**ADDENDUM NO. 1
TO
PROJECT MANUAL
PROJECT/CONTRACT NUMBER: 19-03
ROOFING PROJECT AT MAMMOTH HIGH SCHOOL
MAMMOTH UNIFIED SCHOOL DISTRICT**

AMENDED
EXHIBIT A ("SCOPE OF WORK") TO THE
CONTRACT FOR REPAIRS, MAINTENANCE OR CONSTRUCTION PROJECTS

**SECTION 07 54 20
ADHERED FELTBACK
PVC THERMOPLASTIC MEMBRANE ROOFING**

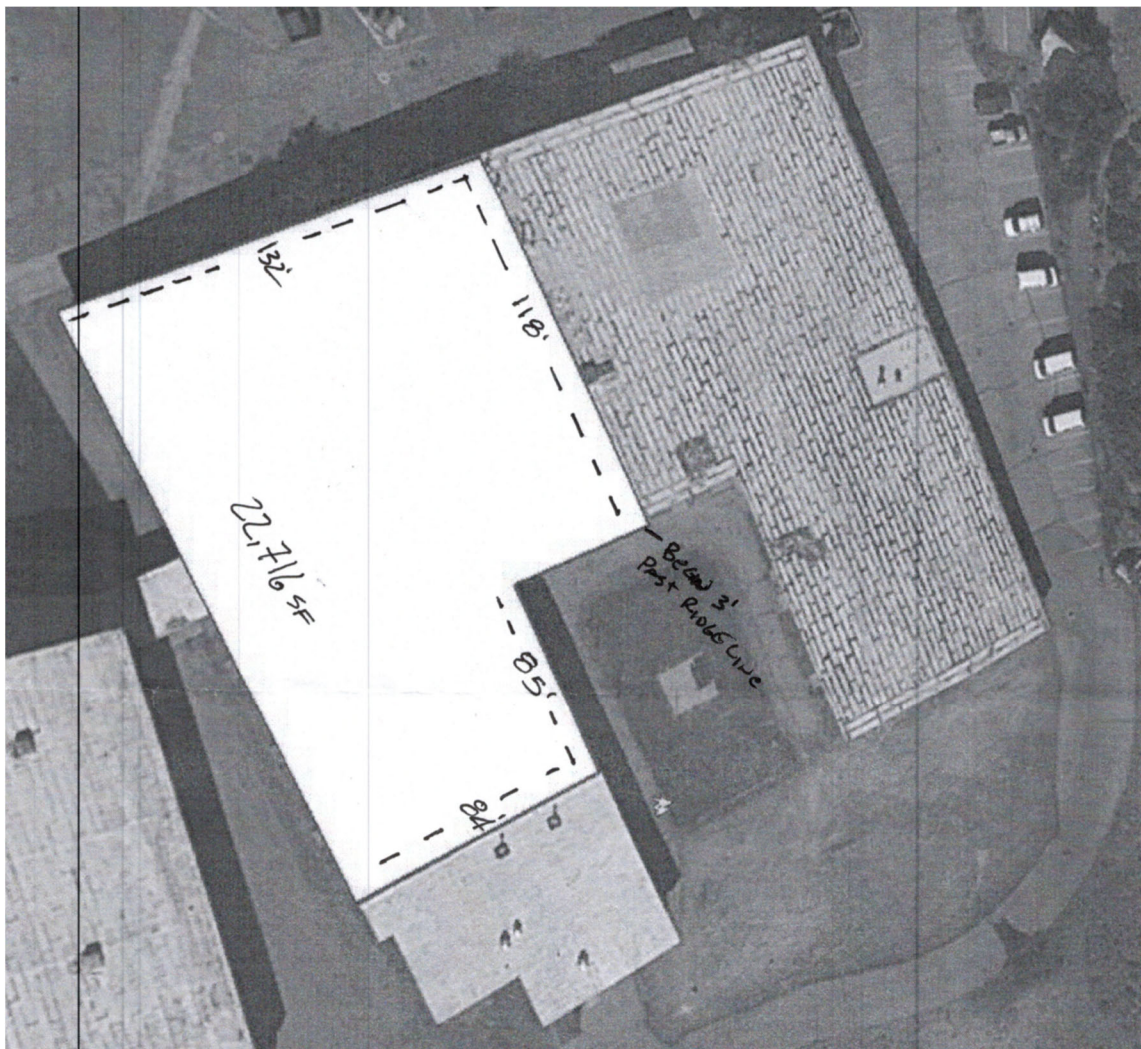
The Project consists of the installation of approximately 22,716 square feet of a new roofing system in the area of the Site as indicated in the picture below.

Base Bid: Contractor shall remove and dispose of existing roofing system and install a new roofing system. The New roofing system shall be: Sika Sarnafil SIKAPLAN Adhered Thereoplastic Polyvinyl-Chloride (PVC) 60 mil, or equal, white, pursuant to attached specification 07 54 20 attached hereto. Do not include the scope identified in Alternate No. 1 below.

Alternate No. 1: Contractor shall install Sarnafil G410, 60 Mil Feltback membrane adhered over 1/2" Dens Deck Prime mechanically fastened over the sloped plywood deck (or approved equal), pursuant to attached specification 07 54 20 attached hereto. Do not include the scope identified in Basic bid.
